SAFETY EVALUATION BY THE OFFICE OF NUCLEAR REACTOR REGULATION

SUPPORTING AMENDMENT NO. 90 TO

FACILITY OPERATING LICENSE NPF-5

EDWIN I. HATCH NUCLEAR PLANT, UNIT 2

FIGURE 3.1.5-1 SODIUM PENTABORATE SOLUTION VOLUME VERSUS CONCENTRATION REQUIREMENTS

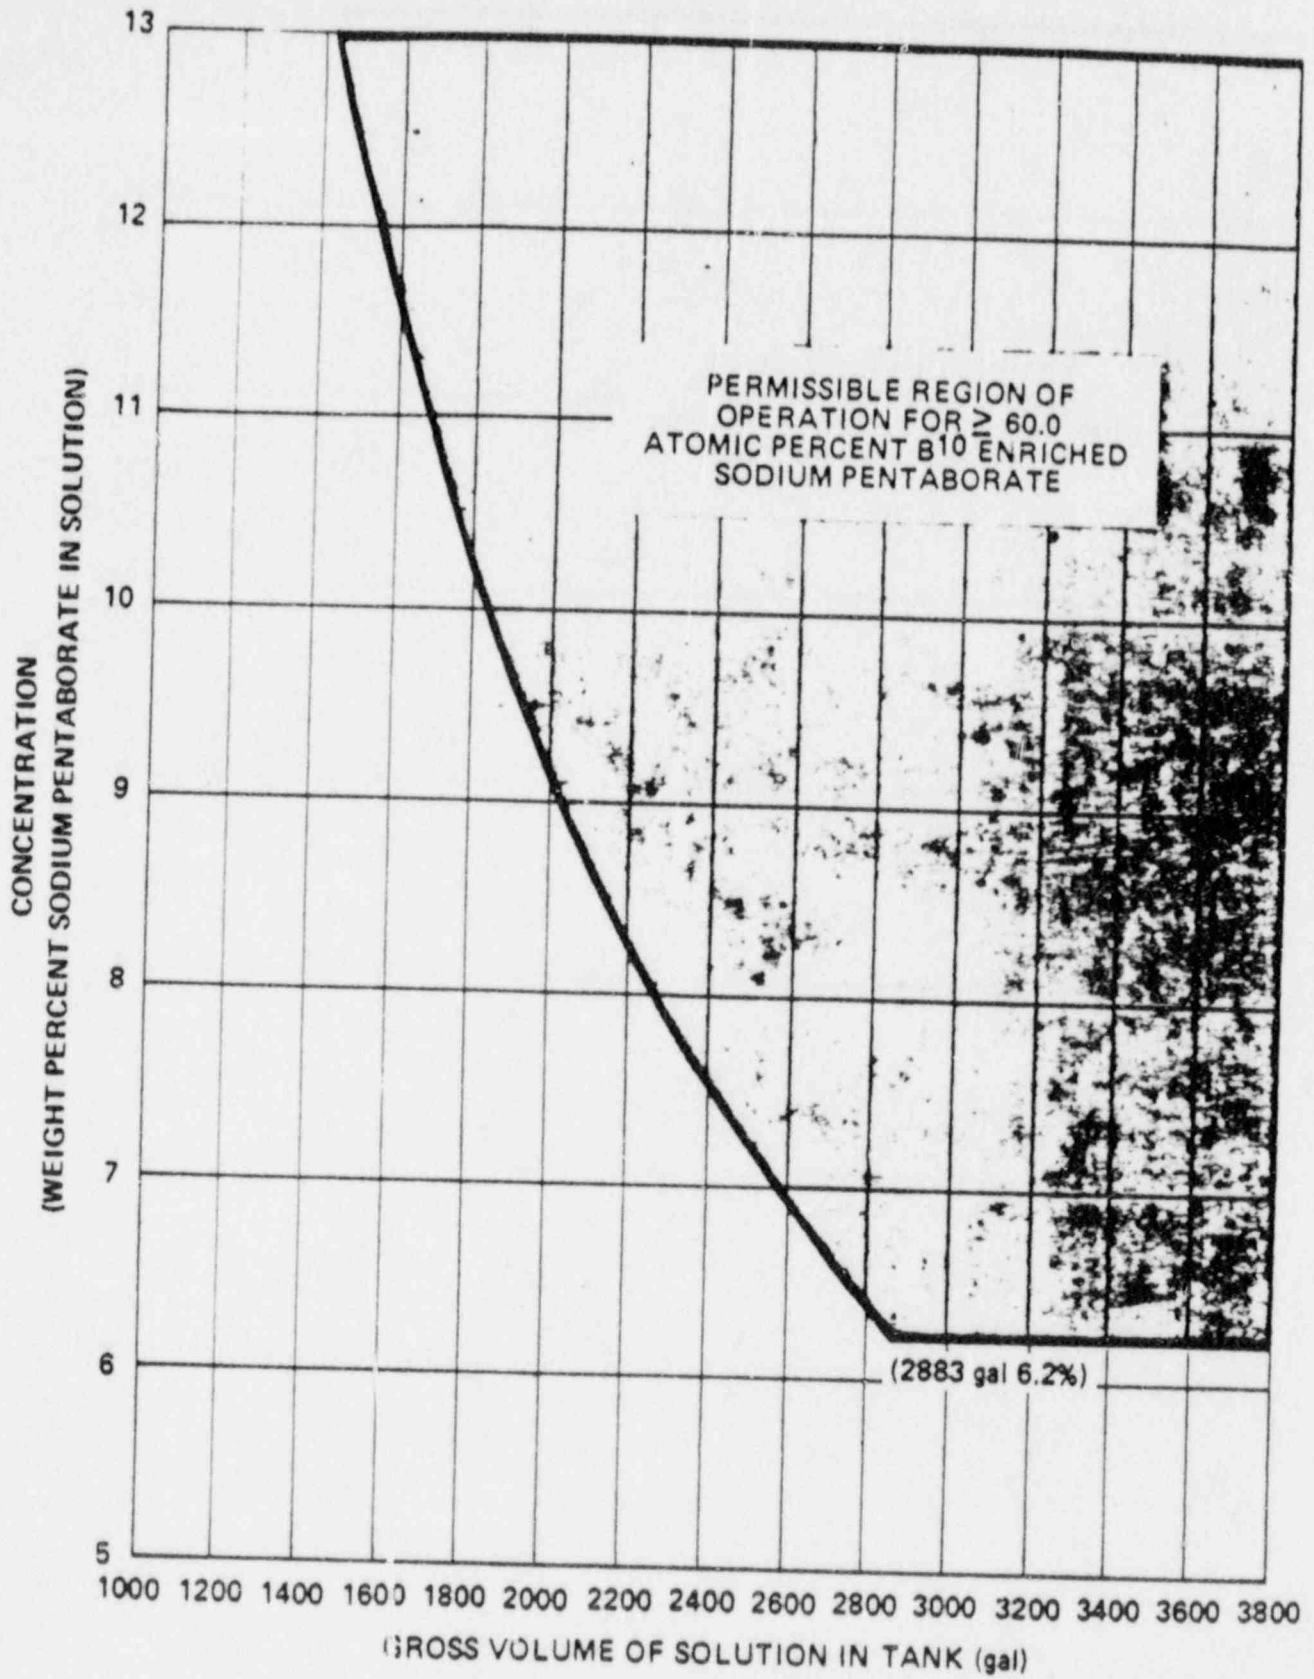
The existing TS 4.1.5 sets limits on the minimum volume of sodium pentaborate solution and the minimum weight of sodium pentaborate in the solution. TS Figure 3.1.5-1 sets minimum solution temperature limits as a function of solution concentration. The licensee proposes to replace TS Figure 3.1.5-1 with a new Figure 3.1.5-1 which establishes an operating range of acceptable solution volumes as a function of the concentration of sodium pentaborate in the solution, and a new Figure 3.1.5-2 which sets an operating range of minimum solution temperatures as a function of sodium pentaborate concentration. The text of TS 3/4.1.5 would be revised to reference the limits shown on these two new figures. The revised minimum solution volume is set at 2,883 gallons when using a 6.2 weight percent solution of sodium pentaborate enriched to 60 percent in the Boron-10 isotope. This volume and concentration maintains the same margin of safety as in the existing TS. For higher concentrations of sodium pentaborate, smaller volumes of solution are required, as displayed on TS Figure 3.1.5-1. The minimum solution temperature required by the graph on TS Figure 3.1.5-2 maintains a constant 10°F margin above the saturation temperature for the solution concentration. The two new figures are identical to those previously approved for the Unit 1 TS (Reference 2). In conjunction with the revisions to the text of TS 3/4.1.5, this approach establishes appropriate limits on the sodium pentaborate solution and is acceptable.

The volume limits in Figure 3.1.5-1 are calculated such that for a given concentration of sodium pentaborate, the tank contains a volume of solution adequate to bring the reactor to a cold shutdown, with margin. These volume limits are based on gross volume and account for the unusable volume of solution in the tank and suction lines.
